# Access Compliance Report

## Public Rights-of-Way

Intersection ID: 10162	Main Street: E_SUGAR_CREEK_RD	Cross Street: THE_PLAZA	Location: SE
ADA ID: 068AB04377BC	Ramp Type: PerpDiag	Initial Pass/Fail: Fail	Overall Compliance: No
Severity Score: 25			
Codes/Mitigation Info/Possible Solution		Field Measurements/Component Compliance

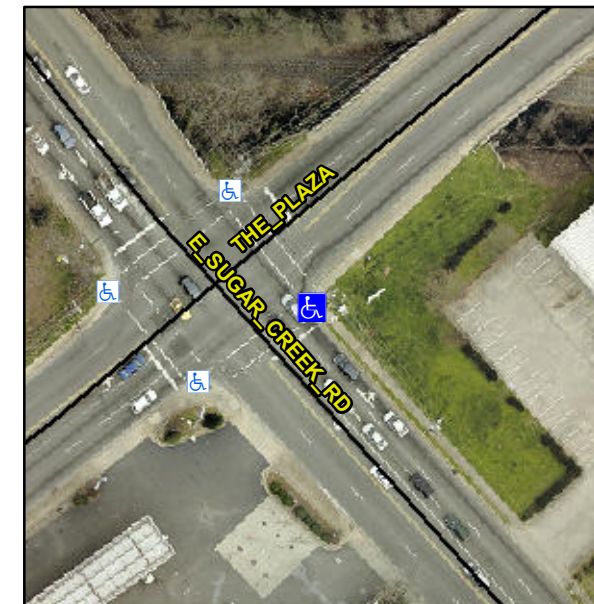
**Remove & Replace Curb Ramp With Two New Directional Ramps or Equivalent.**

**Not Found, R304.5.3**

Compliance	Description	Data	Compliance	Description	Data
N/A	Ramp Length (in)	25.5	Yes	Ramp Slope (%)	5.2
Yes	Ramp Width (in)	48.0	No	Ramp XSlope (%)	10.9
N/A	Flare Type LT	N/A	N/A	Flare Type RT	N/A
N/A	Flare Slope LT (%)	N/A	N/A	Flare Slope RT (%)	N/A
N/A	Flare Traversable LT?	N/A	N/A	Flare Traversable RT?	N/A
N/A	Landing Length (in)	N/A	N/A	DWS Provided?	N/A
N/A	Landing Width (in)	N/A	N/A	DWS Contrast?	N/A
N/A	Landing Slope (%)	N/A	N/A	DWS Length (in)	N/A
N/A	Landing X Slope (%)	N/A	N/A	DWS Full Width?	N/A
N/A	Landing Curb? (Y/N)	N/A	N/A	DWS Offset (in)	N/A
N/A	Shared Landing?	N/A			
N/A	Gutter Ponding?	N/A	N/A	Gutter Slope (%)	N/A
N/A	Gutter Lip Ht (in)	N/A	N/A	Gutter X Slope (%)	N/A
N/A	Painted X Walk1?	Yes	N/A	Painted X Walk2?	Yes
	X Walk 1 Direction	To NW		X Walk 2 Direction	To SW
N/A	X Walk 1 Width (in)	103.0	N/A	X Walk 2 Width (in)	108.0
	X Walk 1 Slope (%)	7.6		X Walk 2 Slope (%)	1.3
	X Walk 1 X Slope (%)	4.2		X Walk 2 X Slope (%)	7.8

N/A	Ramp inside XWalk1?	Yes	N/A	Ramp inside XWalk2?	Yes
	Road Slope (%)	6.8	N/A	Clear Space?	N/A
	Road X Slope (%)	5.5	N/A	Clear Space to XWalk (in)	N/A
N/A	Any Obstructions?	N/A	N/A	Storm Grate/Utility Hazard?	N/A
	Obstruction Type			Storm Grate/Utility Type	
		N/A			N/A
		Yes		Surface Condition? (G/P)	Good
